Arlington County Historical Affairs and Landmark Review Board
Design Review Committee Meeting, 6 December 2023

REQUESTED REVISIONS TO HALRB CERTIFICATE OF APPROPRIATENESS
17 March 2021, Case 19-27A (HPCA21-00007)

WALKER CHAPEL HISTORIC CEMETERY PROJECT (HCP)

CoA REVISION REQUEST No. 2:
STEP LIGHTS AND RETAINING WALL LIGHTS

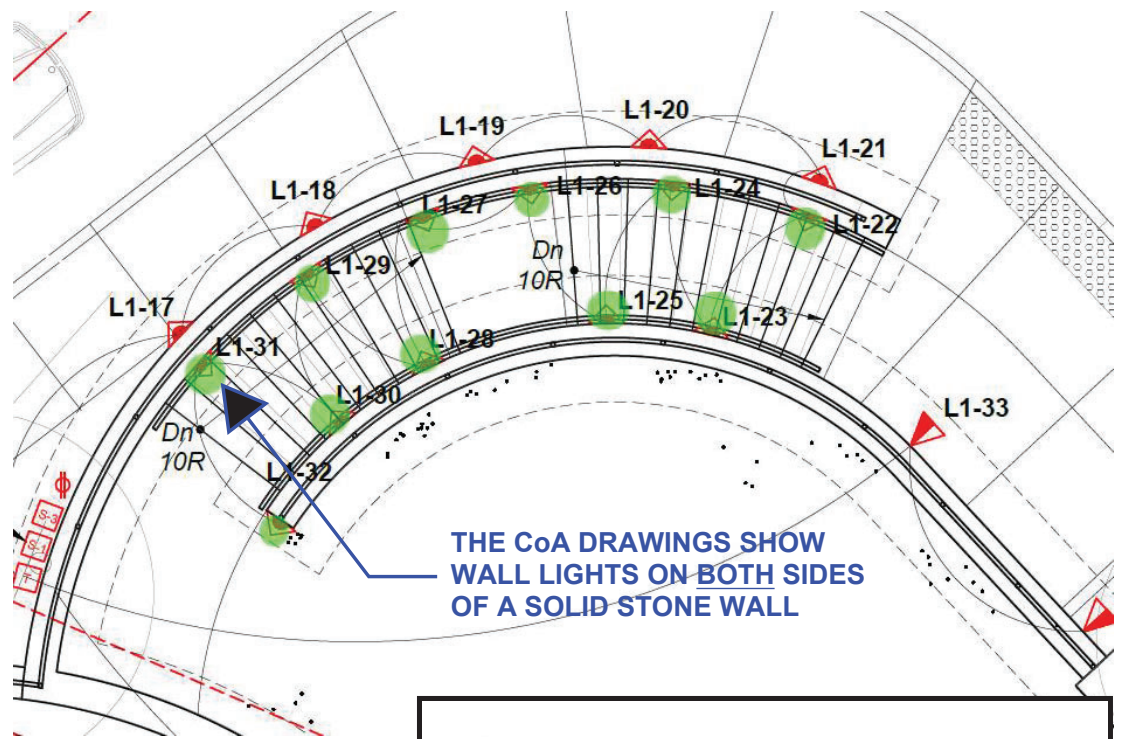
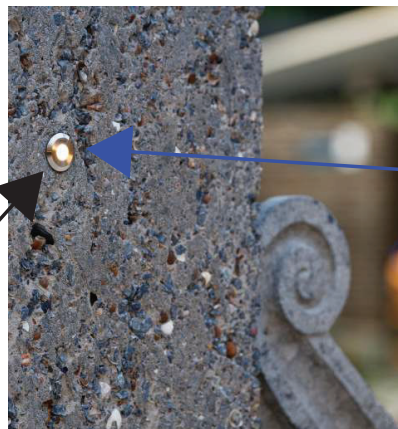
The CoA was based on use of small wall lights on the stair walls. This design assumed a reinforced concrete wall structure with thin stone veneer and conduit set in the concrete form work.

The actual wall construction is a natural stone "gravity wall" system in which there is no form work, making conduit access to both sides of a finished wall all but impossible. The Owner Construction Phase Representative approved a contractor-recommended substitution to use conventional step lights set in alternating risers of the poured-in-place concrete stairway. With this installation, conduit could be set in the form work.

**CoA REVISION REQUEST No. 4:
PARKING LOT LIGHTS**

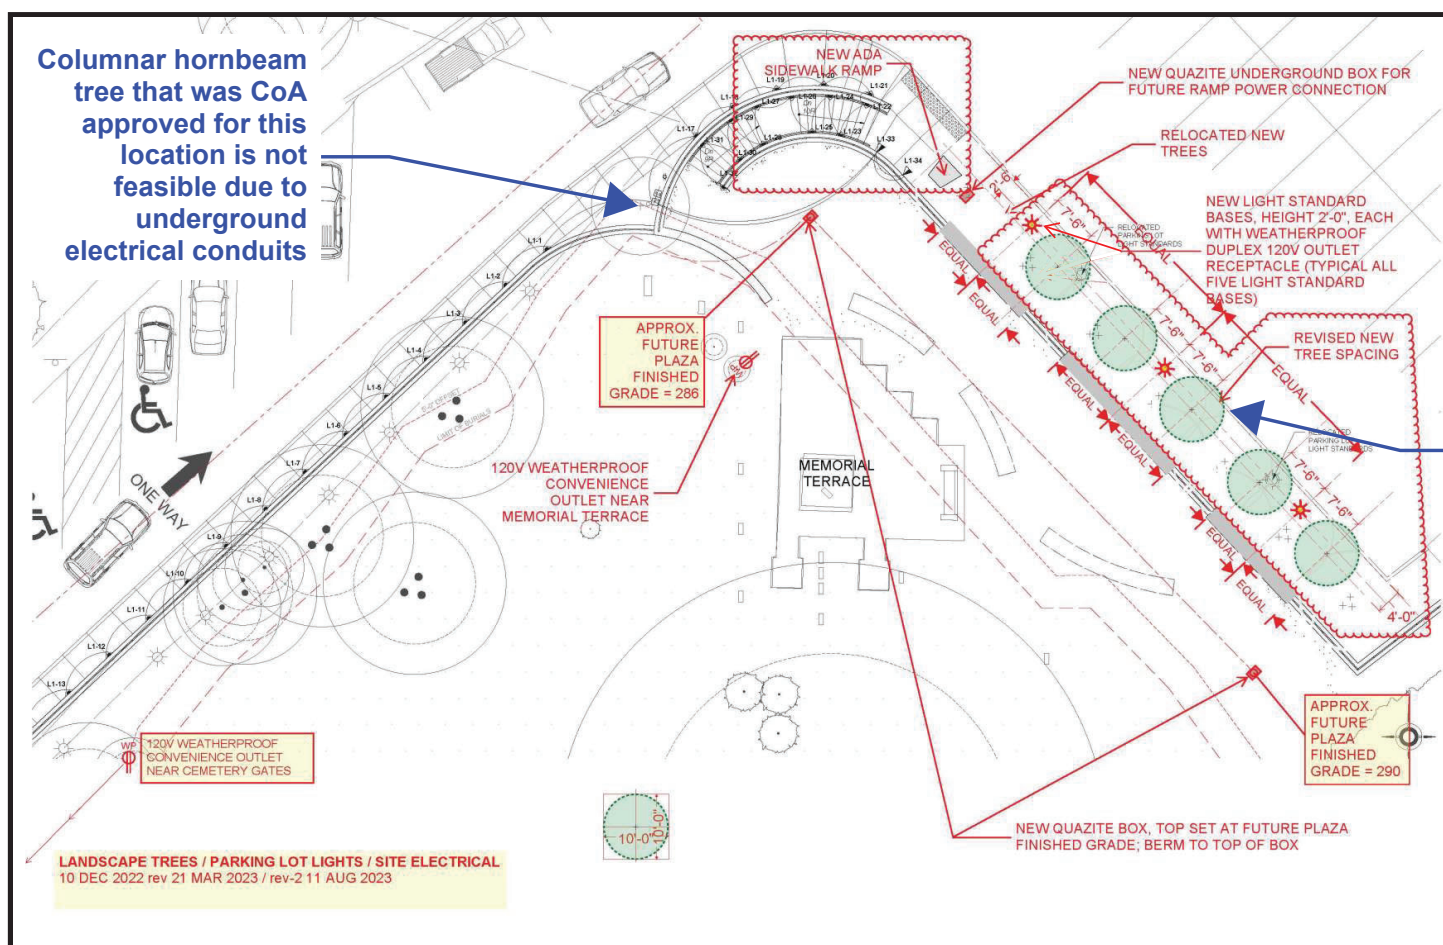
The CoA-approved site plan (L004) indicated four re-installed parking lot light fixtures. Originally, there were in fact five existing parking lot light fixtures.

The church wants the same parking lot light coverage as was in the pre-project condition -- three light standards on the south (cemetery) side of the parking lot, and two on the north (N. Tazewell St.) side. The five light standards were re-installed as before, with the positioning of the three on the south side adjusted to respond to the architecture of the cemetery retaining wall columbaria (for details, see CoA Revision Request No. 5 below). As a technical note: the original lamp heads were found to be in a state of disrepair making their reuse unfeasible; new, matching lamp heads were installed using the existing poles, all of which were repainted.

PLANTING PLAN (continued)

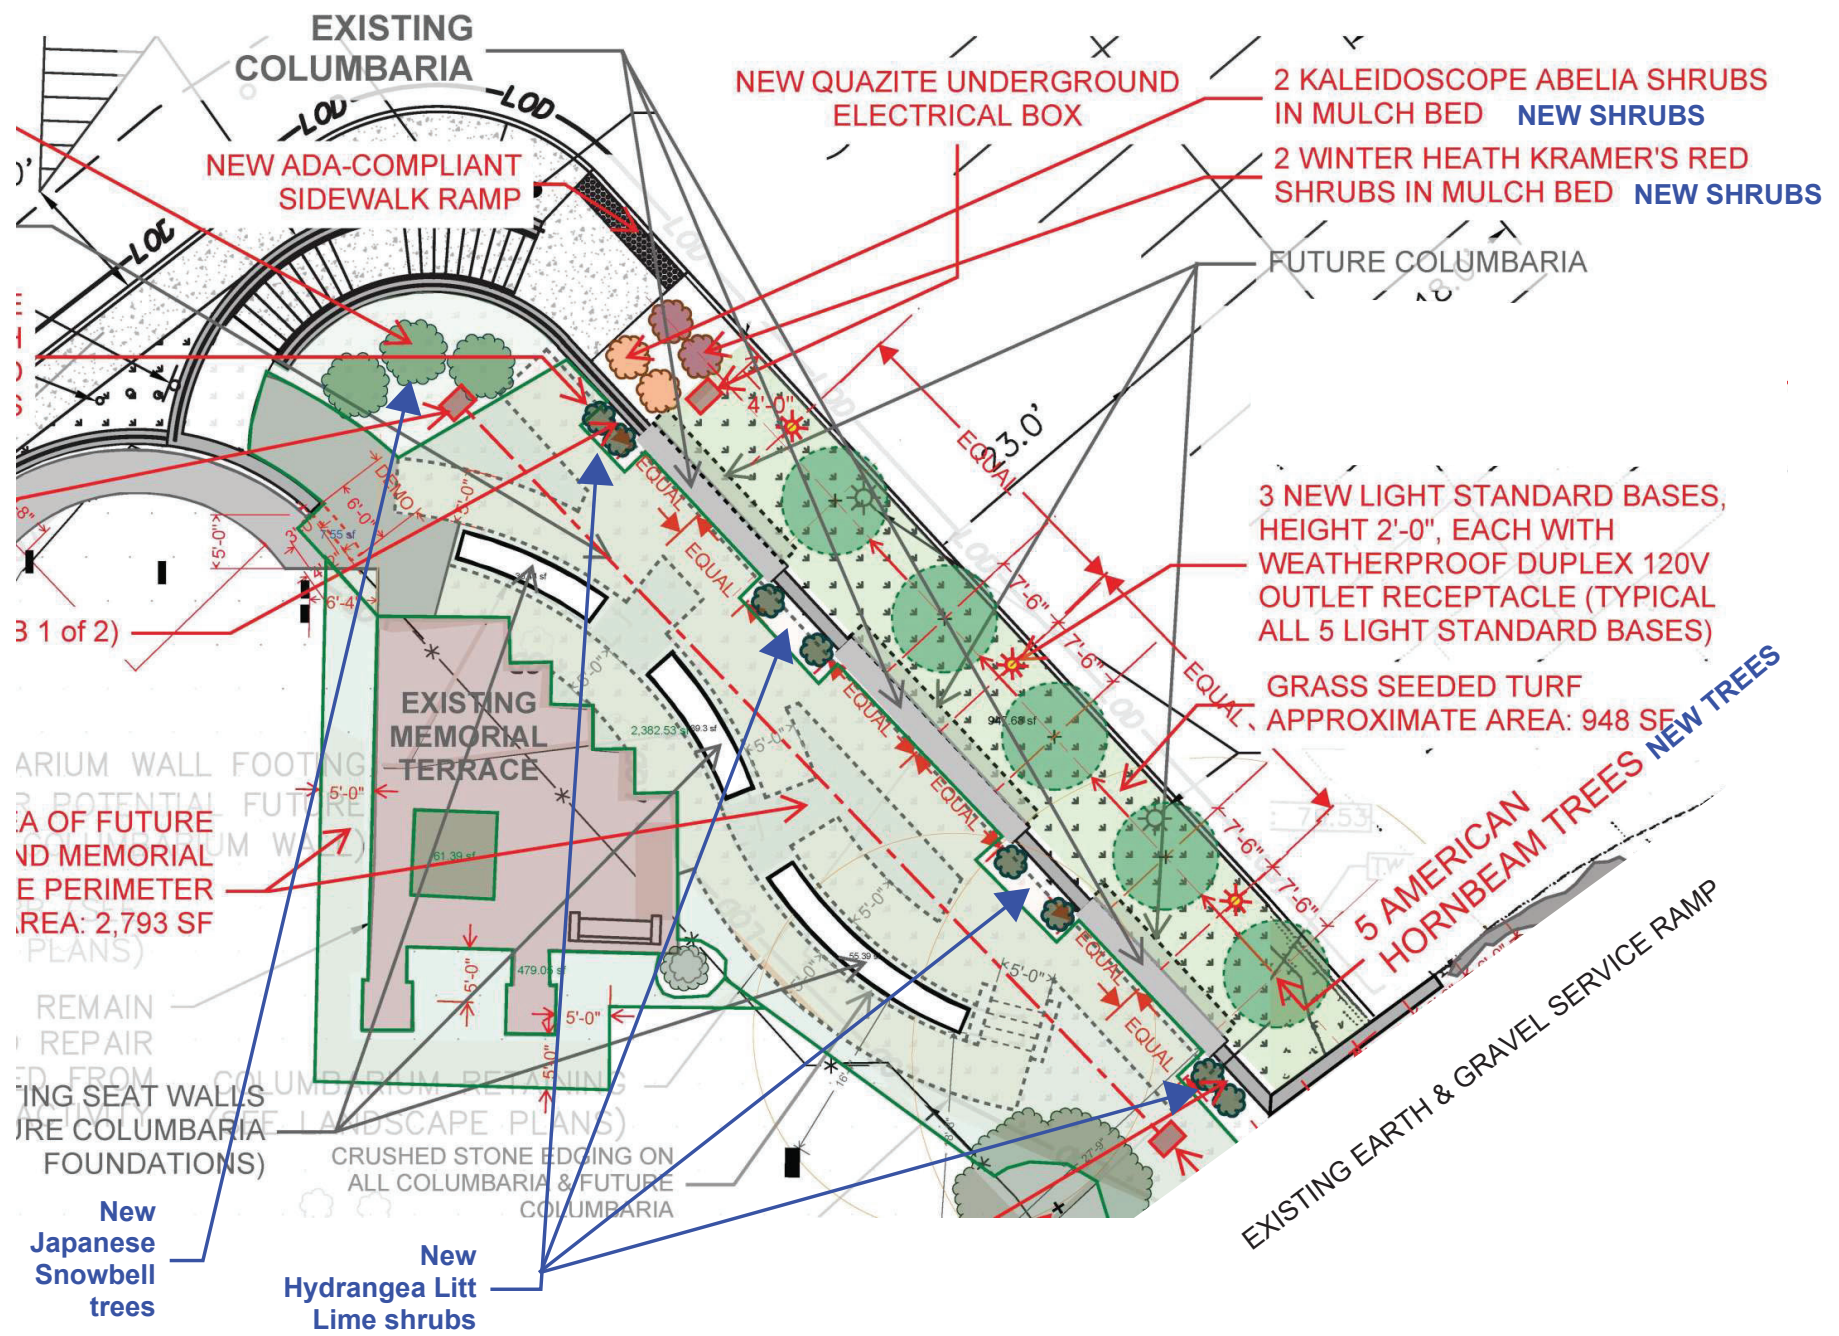
Aside from the aforementioned trees, the CoA approved planting plan (L104) did not include any other new landscape plant elements.

Feeling the need for a small amount of supplemental landscaping as the project neared completion, the Owner's Planning Representative worked with Merrifield Garden Center to provide and plant additional trees and shrubs.

PROPOSED NEW SERVICE RAMP

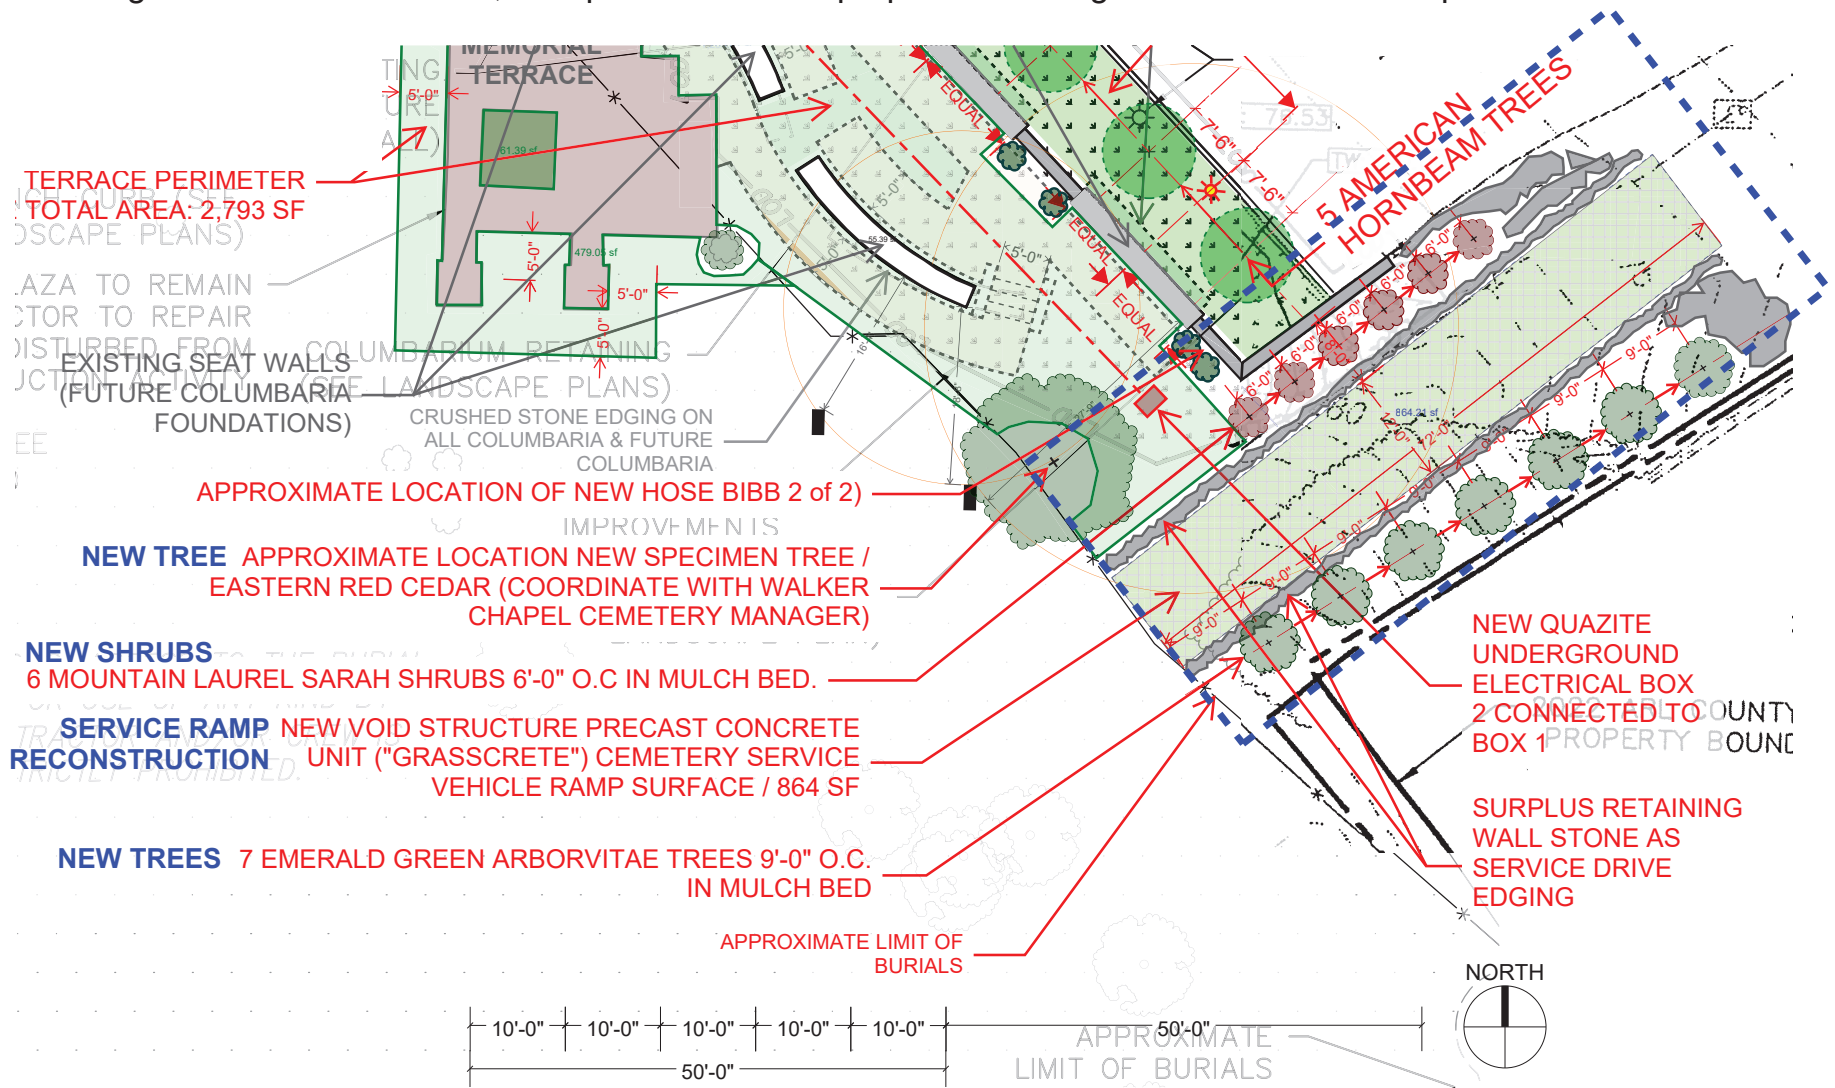
In support of its ongoing interment and cemetery maintenance needs, the church wishes to construct a permeable paver service ramp atop the existing earth and gravel ramp. This ramp is used sporadically when there is a need for service vehicles to access the cemetery; this is the only access point to the cemetery from existing roadways surrounding the church grounds. The proposed ramp would also support the weight of an emergency vehicle should there be a need for one to access the cemetery.

The new service ramp will be constructed using Belgard Turfstone precast concrete product. This is a permeable paver type. The reconstructed ramp will be lined with loose natural stone, the same stone as used on the new retaining wall. As shown below, new plant material is proposed flanking both sides of the ramp.
